APPLICATION FOR A RESIDENTIAL SITE IMPROVEMENT PERMIT/ CONSTRUCTION AUTHORIZATION FOR AN ON-SITE WASTEWATER SYSTEM, NEW WELL INSTALLATION, OR REPAIR OF EXISTING WELL

Re: Application for improvement permit for:
Property Location: 13725 E Rocky River Rd., Davidson, NC 28036 (PID 003-121-02)
Health Department File Number: **1328A (AppID: 6106)**

SOIL/SITE EVALUATION for ON-SITE WASTEWATER SYSTEM

Sketch of Soil Evaluation Locations

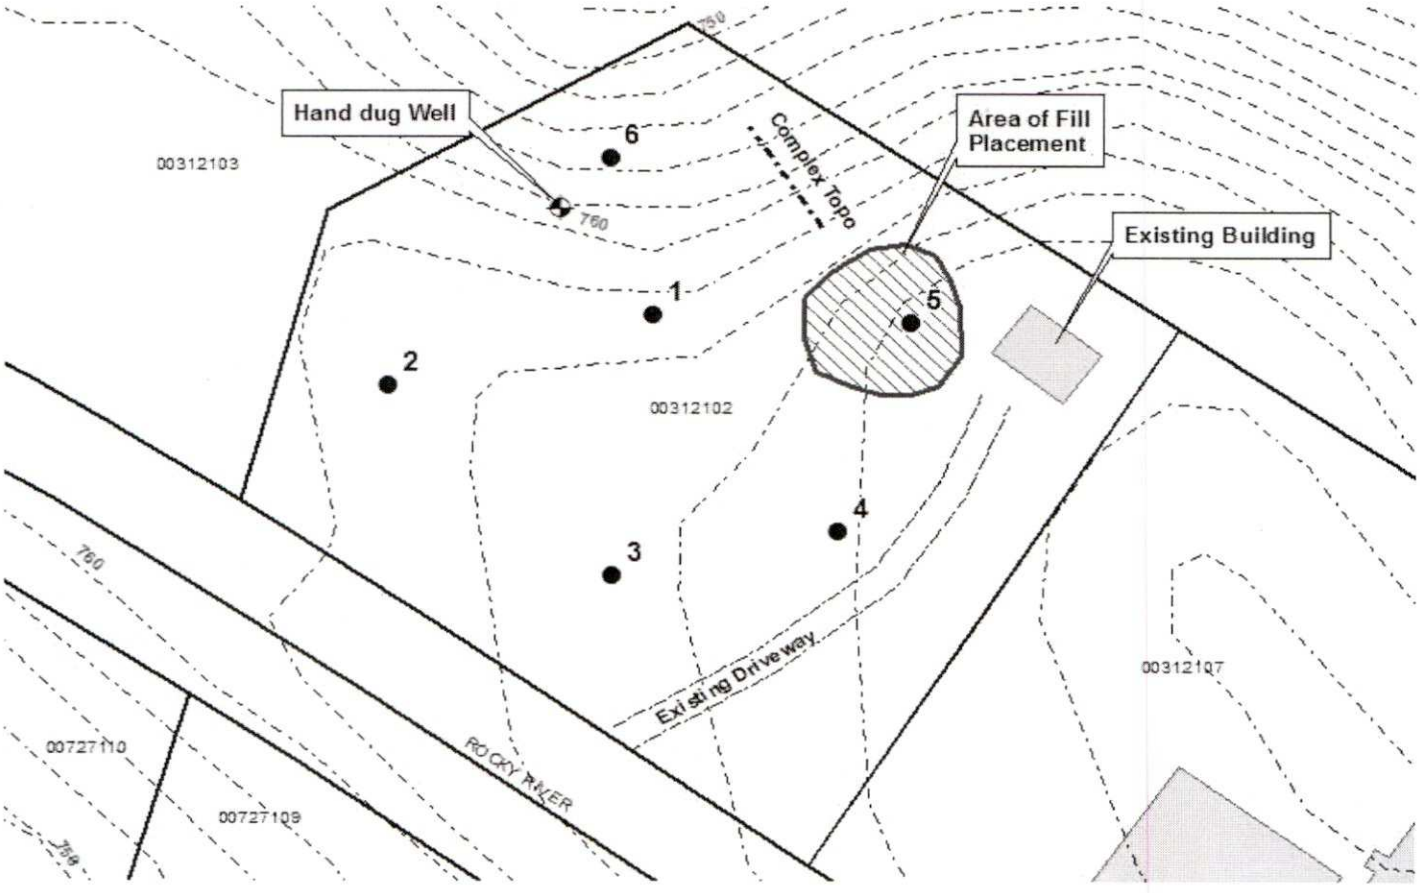
PROFILE #	.1940 Landscape Position/ Slope%	Horizon Depth (IN.)	SOIL MORPHOLOGY .1941 .1941 Structure/ Texture	.1941 Consistence Mineralogy	b PROFILE FACTORS .1942 Soil Wetness/ Color	.1943 Soil Depth (IN.)	.1956 Sapro Class	.1944 Restr Horiz	General Comments	Profile Class & LTAR	Maximum Trench Bottom Depth for 3' Wide Conventional Trench
Boring #1	LS 12%	0 - 9	wmgr SCL	S SP FR SEXP							
		9 - 23	wmsbk SC	S P FI SEXP	10YR 7/1 @ 17"	23	NA	NA		US	NA
Boring #2	R 3%	0 - 6	wfsbk C	S P FI SEXP					Expansive Clay seams in Saprolite		
		6 - 15	mass LS	VFI	10YR 7/1 @ 12"	15	NA	NA		US	NA
Boring #3	R 3%	0 - 7	wmgr SL	SS SP FR SEXP							
		7 - 13	wfsbk C	S P FI SEXP	10YR 7/1	18	NA	NA		US	NA
		13 - 18	wfsbk C	S VP VFI EXP	@ 13"						
Boring #4	R 3%	0 - 10	wmgr SL	SS SP FR SEXP							
		10 - 22	wfsbk SC	S P FI SEXP	10YR 7/1 @ 17"	22	NA	NA		US	NA
Boring #5	R 4%	0 - 24	Fill Soils			0	NA	NA		US	NA
Boring #6	LS 15%	0 - 9	wmgr SL	SS SP FR SEXP

9 - 23	wfsbk SCL	S SP FR SEXP	10YR 7/2					US	NA
		23 - 30	wfsbk C	S VP VFI EXP	@ 29"	30	NA	NA		(0.1 drip)

Other Factors (.1946):
Soil Evaluation By: Jacob Presley, LSS, REHSI
Others Present:
Site Classification (.1948): Unsuitable
Site Evaluation By: Jacob Presley, LSS, REHSI
Others Present:
